3/4.8 ELECTRICAL POWER SYSTEMS3/4.8.1 A.C. SOURCESA.C. SOURCES - OPERATINGLIMITING CONDITION FOR OPERATION

LA SALLE - UNIT 1

3/4 8-3

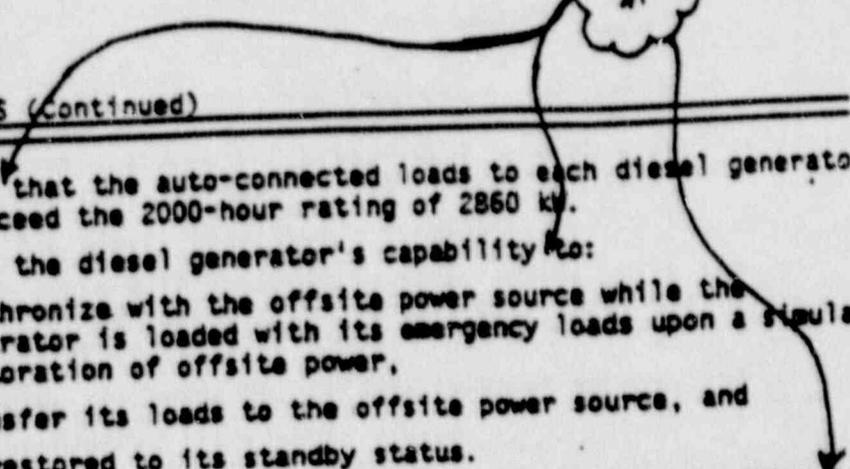
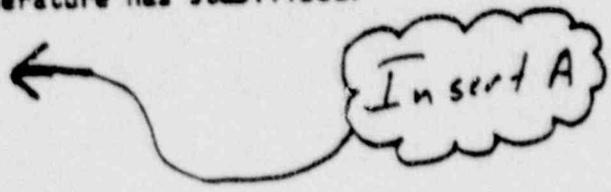
If Surveillance Requirements 4.8.1.1.2.d.4.a)2) and/or b)2) are not satisfactorily completed, it is not necessary to repeat the preceding 24 hour test. Instead, the diesel generator may be operated at 2600 kW for 1 hour or until operating temperature has stabilized. | 7/3/89
